Model type:
LV62BK

Commercial code:
F026564

Notices

n1045034: New top condenser.

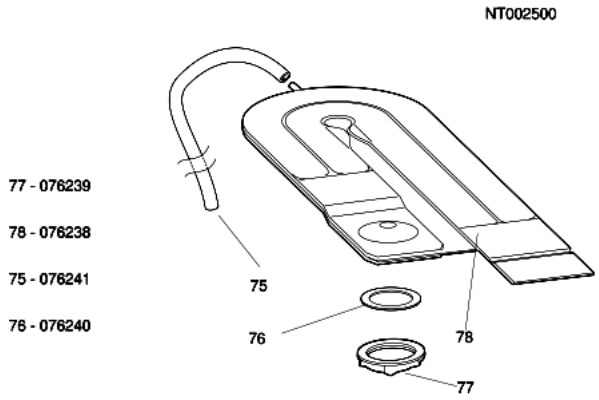
As of the last week in July 2000, the new "Wind drying system" was inserted on some appliances from the new MarckII Range.
This new system foresees the elimination of the lateral air-flow body and the insertion of a new system with top condenser.
The spare part numbers eliminated are as follows:

054927(Rohs 144335) - RING NUT FOR AIR-FLOW BODY
054928 - AIR-FLOW BODY
103689 - NOZZLE GASKET
057874 - TOP SOUNDPROOFING LAYER

Whereas the new spare part numbers are:

076238 - WIND DRYNG SYSTEM CONDENSER
076239 - CONDENSER RING NUT
076240 - TOP CONDENSER GASKET
076241 - TOP CONDENSER PIPE

The new part numbers are not interchangeable with the old ones, as they are completely different. See technical drawing attached to notice NT002500.

n1045056: MARK II LOWER TANK SEAL

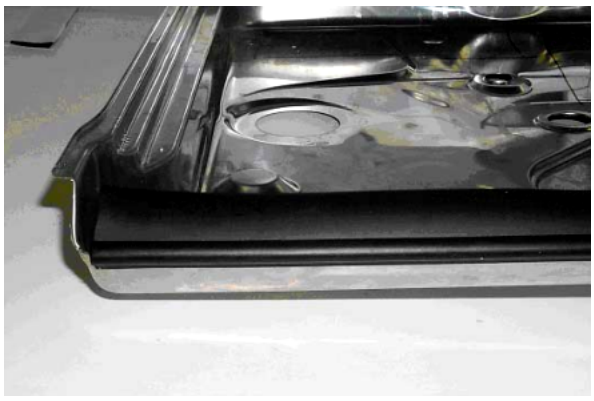
In order to resolve the problem of water leaking from the bottom of the door, all dishwasher models affected by this modification, from serial number 20420.0001 on, have been equipped with lower tank seal, sat code 088505.
See figure "N1045056"

Photo N1045062FIG1 illustrates the bottom of the dishwasher with EVO structure.

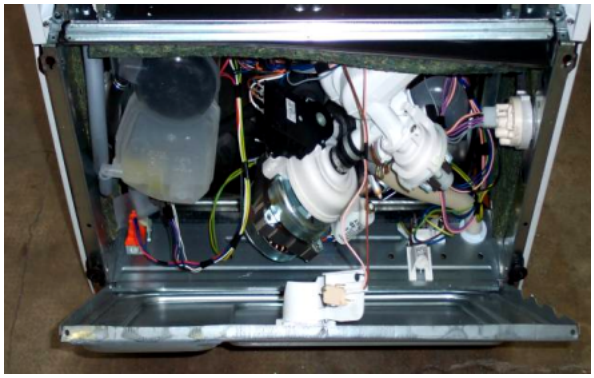
From serial number 30101.0001, all dishwasher models affected by this modification have been produced with EVO structure. These models have been equipped with NEW TRAYS AND NEW FEET (see N1045062TAB1).

PREMODIFICATION:
Tray: 083625 (for commercial code 28490) 078809 (for commercial codes 26043-23520-28088);
Tray rear feet: 078396-078397-078385;
Tray front feet: 073972;
Front feet supports: 065836(Rohs 143584);
Feet supplied with plinth accessories assembly: 034261;

EVO STRUCTURE:
Tray: 092558 (for commercial code 28490) 092554 (for commercial code 26043-23520-28088);
Tray rear feet: 092820-092821-092822;
Tray front feet: 092555;
Front feet supports: 065836;
Feet supplied with plinth accessories assembly: 034261.

Regulation assembly DX/SX Sat codes 078397 and 078396 will be managed up to stock end, after that they will be replaced by new Sat codes 092821 and092820. The same is for rear foot Sat code 078385 which will be replaced by Sat code 092822.

N1045063

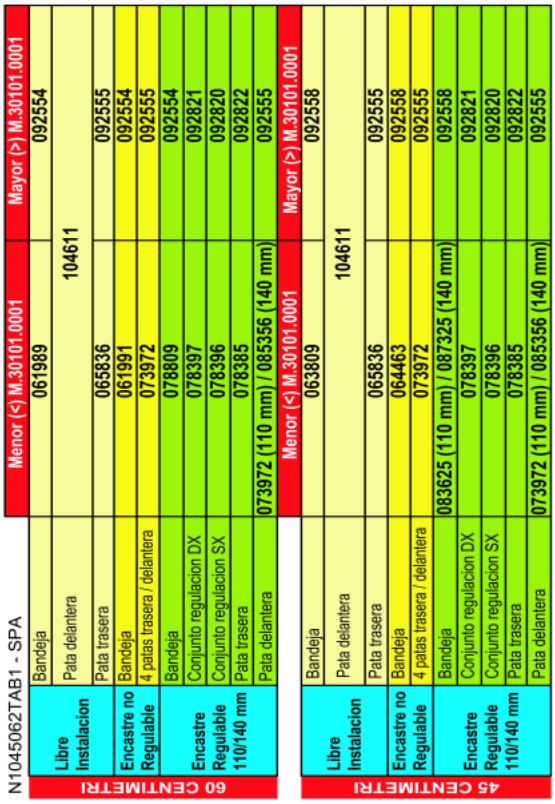
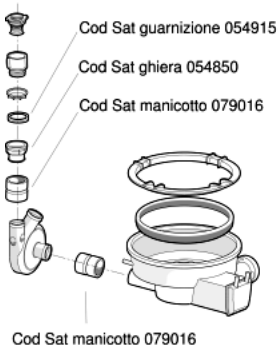
From serial number 30224.0001, all dishwashers affected by this modification have been equipped with the new coupling+ring nut assembly Sat code 093752, in place of coupling Sat code 079016, ring nut Sat code 054850 and gasket Sat code 054915.

Ring nut Sat code 054850 will continue to be available from the spare parts warehouse while stocks last, and coupling Sat code 079016 will continue to be stocked because it is still used for the tank-volute connection.
Picture N1045063 illustrates the premodification structure in FIG1 and the new structure in FIG2.

N1045081FIG1

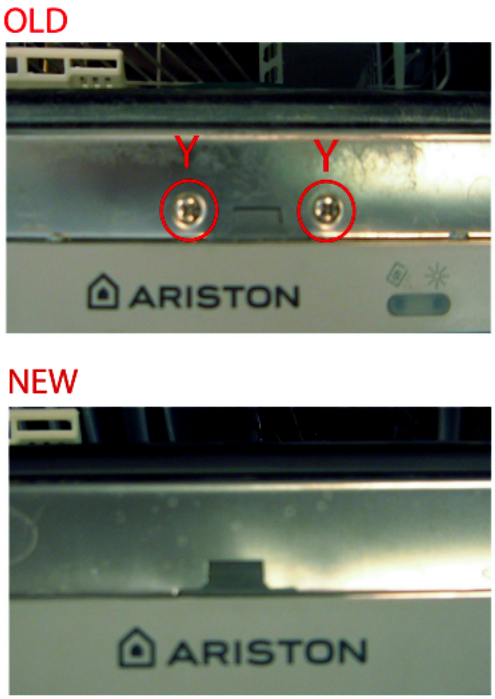
From serial no. 40614.0001, all 60 cm dishwashers affected by this note have been equipped with the locking unit code 094128 in place of 085357.
Following the elimination of the two screws Y (see N1045081FIG1) used to fix the locking unit on the inside door, the locking

unit and inside door were also modified, which can be mounted on premodification appliances by replacing the premodification locking unit with the new one.

Codes of modified inside doors:
085023 PREMODIFICATION - 112451 NEW
